AR KANSAS  
Department of Environmental Quality

AFIN: \_\_\_\_\_ Permit No.: \_\_\_\_\_  
Date: 11/30/07 By: \_\_\_\_\_  
Project: El Dorado Chemical Company  
Remedial Action Workplan  
Sheet \_\_\_\_\_ of \_\_\_\_\_

# **Remedial Action Workplan**

Figure 2.1. Monitoring/Recovery Well location map.

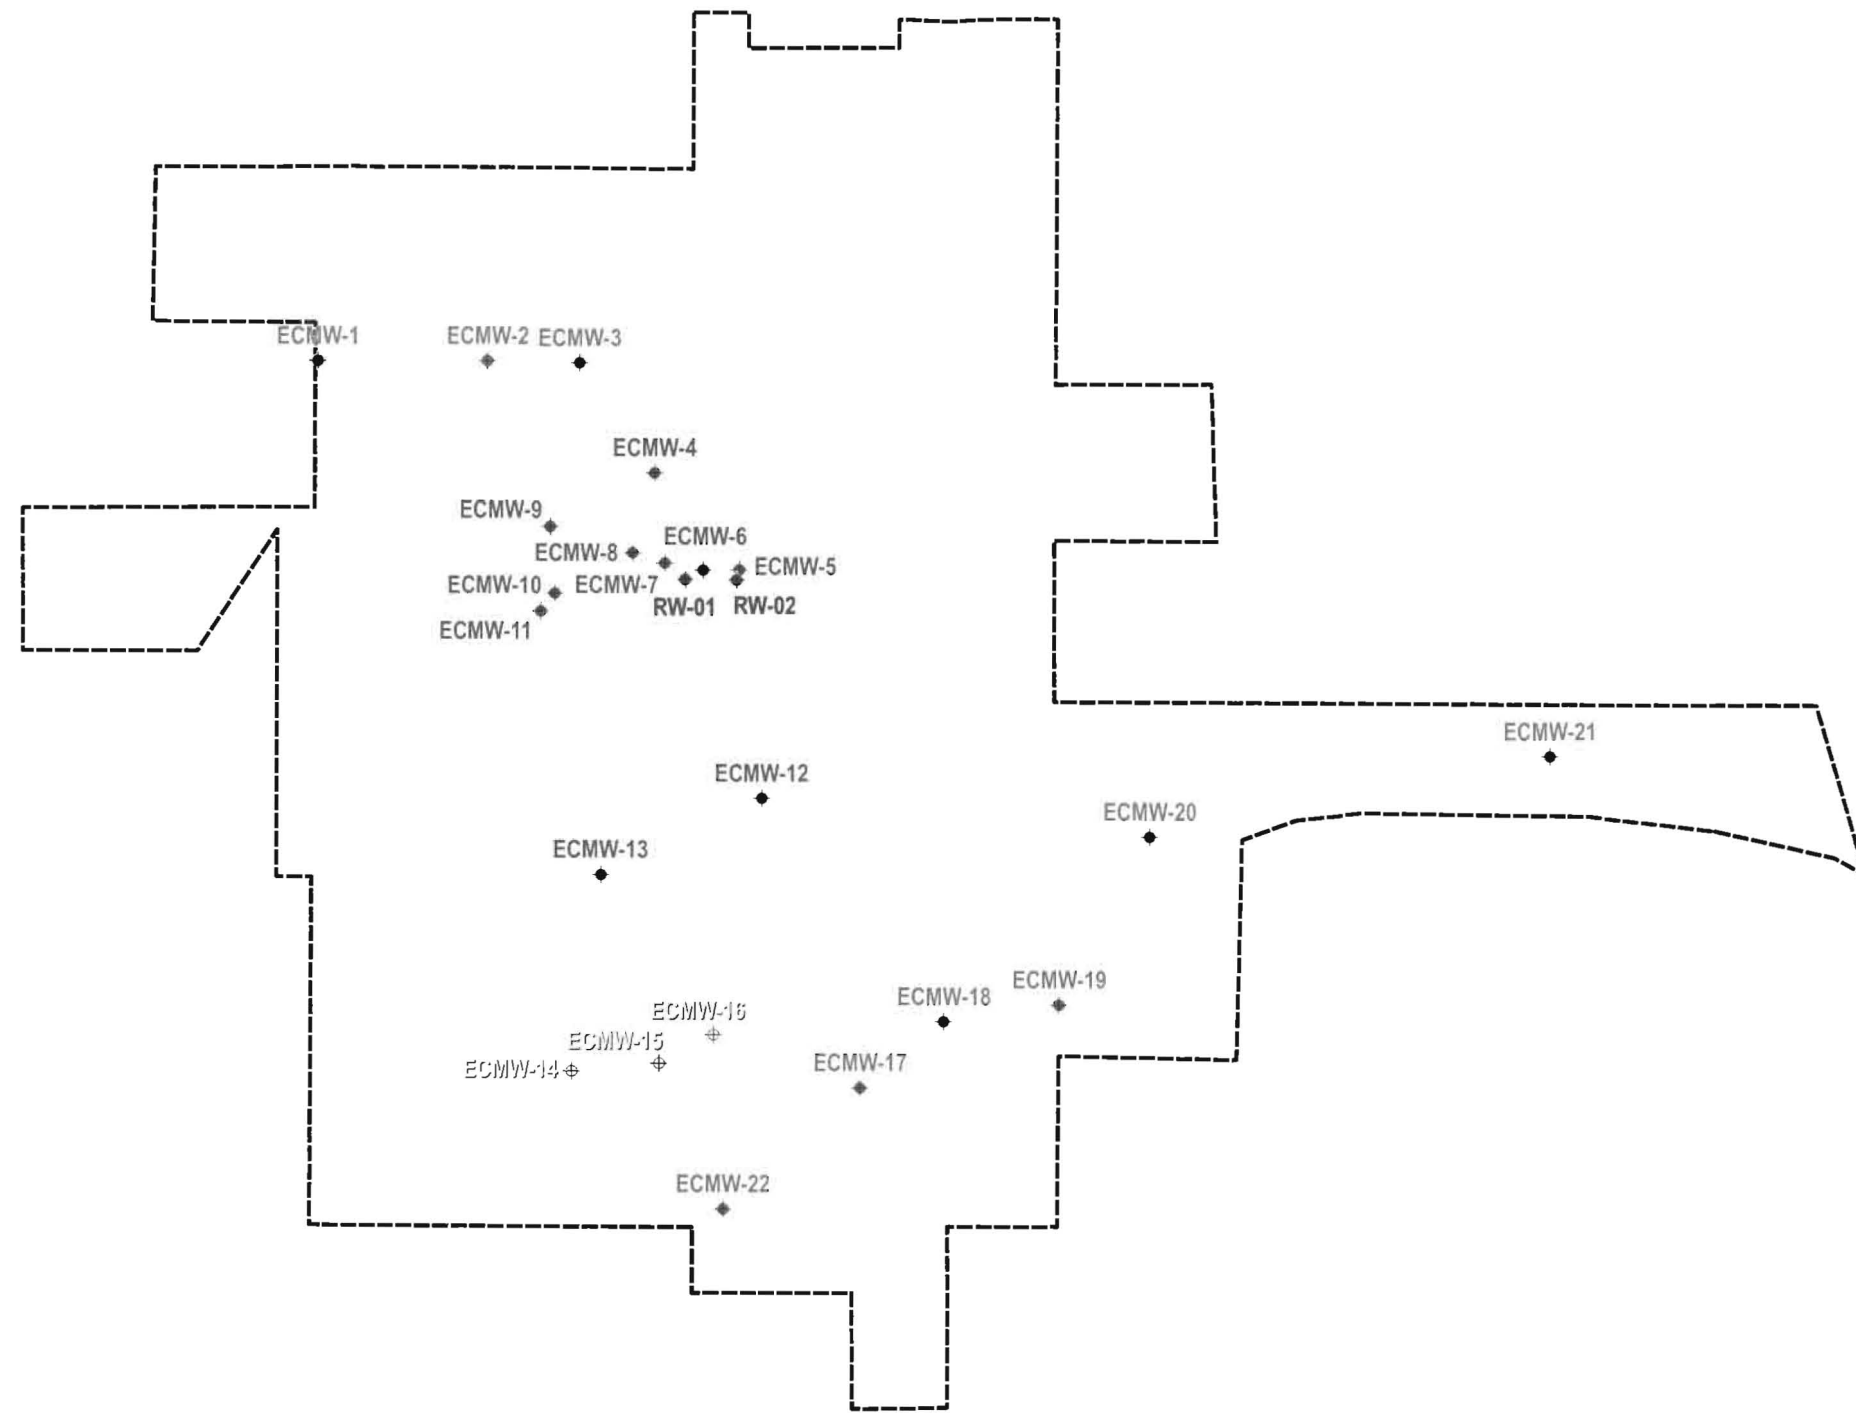
1. Executive Summary, page 1: The third bullet states "Periodic review of off-site domestic wells". Explain/Clarify. Does this "review" include or consist of sampling or monitoring of the off-site domestic wells? What is meant by periodic? Semi-annually? Annually? Bi-annually?  
What is the relationship (depth, stratigraphy, i.e., hydrogeology) between the ammonia contamination, groundwater recovery system, and the off-site domestic wells?
2. 1.1 Purpose and Objectives, page 1 and 1.2 Risk Assessment Findings, page 2:  
What is/was the concentration of ammonia in the groundwater?  
What is the extent of ammonia contamination in the groundwater (i.e., what is the size of the plume?)?
3. 2.3 Selected Remedy, pages 6-7: What is the pumping rate (i.e., gpm) of the recovery wells?  
What is the size (extent) of the capture zones for the recovery wells?
